Architectural Review Board

Staff Report (ID # 9943)

Summary Title: 4256 El Camino Real: New Hotel (2nd formal)

Title: PUBLIC HEARING / QUASI-JUDICIAL. 4256 El Camino Real (18PLN-00096): Recommendation on Applicant's Request for Approval of a Major Architectural Review for a new 51,861 Square Foot Five-Story Hotel Including 100 Guest Rooms and Below-Grade Parking. Director's Adjustment Requested for a Reduction in Required On-site Parking (15%) and Loading Space Dimensions. Environmental Assessment: A Mitigated Negative Declaration was Prepared Pursuant to the California Environmental Quality Act (CEQA) and is Being Circulated for Public Comment Between January 7, 2018 and February 6, 2018. Zone District: CS (Service Commercial). For More Information Contact the Project Planner Samuel Gutierrez at samuel.gutierrez@cityofpaloalto.org.

Previous Design

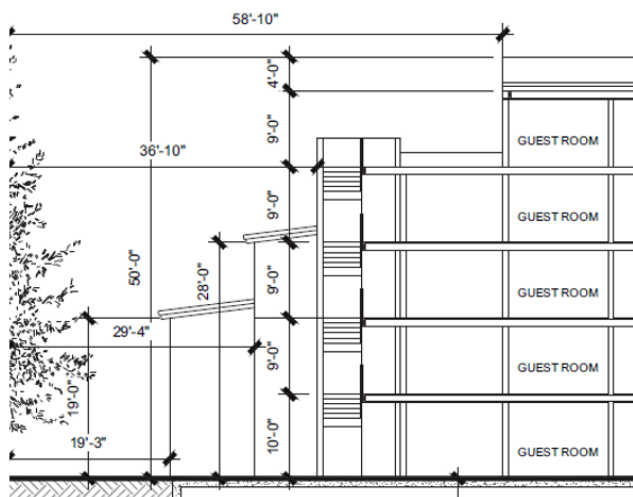
The stair tower located on the northern portion of the building was revised by the applicant, along with materials and color changes to the façade of the building. Additionally, the roof forms adjacent to the tower have been revised to better match the top of the stair tower with the building. The color and materials changes to the building façade frame the stair tower and visually identify it as a element of the overall building with a different function than those directly adjacent to it. Though this seems to be an improvement over the previous design, the ARB's feedback on this element and its compatibility with the building is desired.

Previous Design

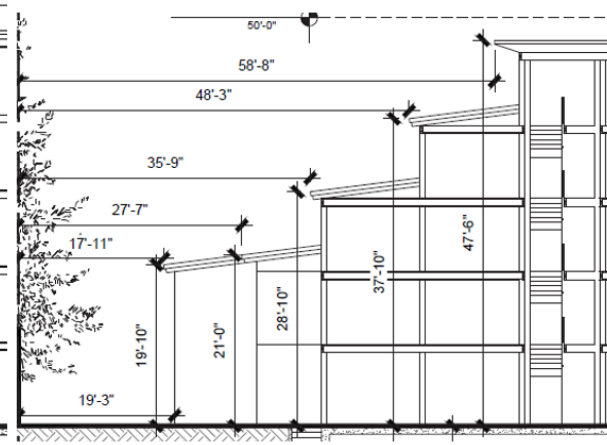
As shown in the sections below (Sheet A-6.0), the upper levels of the proposed hotel have been moved away from the adjacent residential project to increase light and air for all uses.
